Summit Park Church Preliminary Development Plan

File #PL2021-283

October 19, 2021

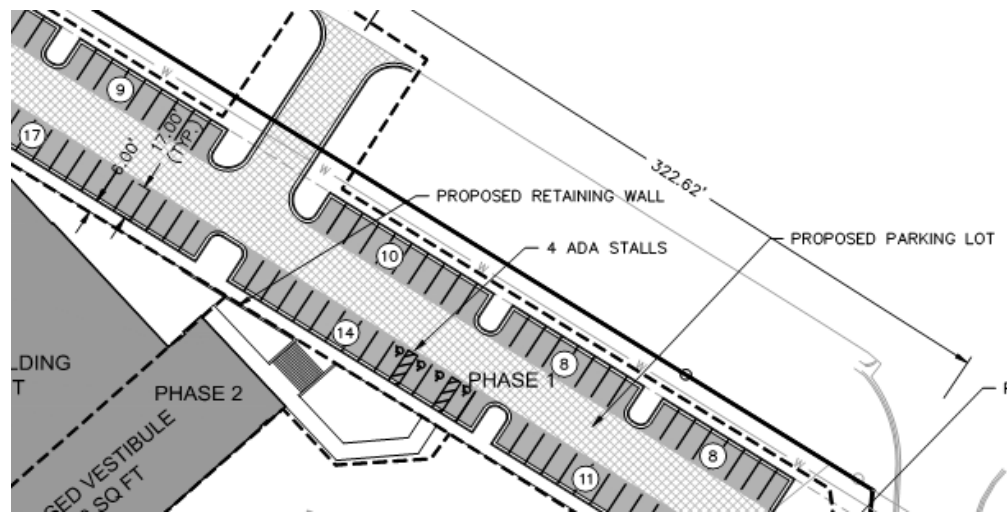
- **Required** - The UDO requires parking lots to be set back a minimum 20' from any public right-of-way.
- **Proposed** - The propose parking expansion is set back approximately 15' along the SW Oldham Pkwy right-of-way.

- **Recommended** – Staff supports the requested modification. Common to properties in the City along US 50 Hwy and M-291 Hwy is the presence of an excess amount of right-of-way width that results in parking lots with reduced setbacks from the right-of-way yet still maintain a significant amount of separation between the parking lot boundary and the actual highway and / or frontage road travel lanes. In this particular case, the parking lot is set back 15' along the SW Oldham Pkwy frontage road vs. the minimum required 20'. However, the parking lot is set back approximately 72' from the SW Oldham Pkwy travel lanes. Along SW Oldham Pkwy, it is not unusual to see existing development with as little as 0' parking lot setback that maintain at least 20' of separation between the parking lot and frontage road travel lanes.
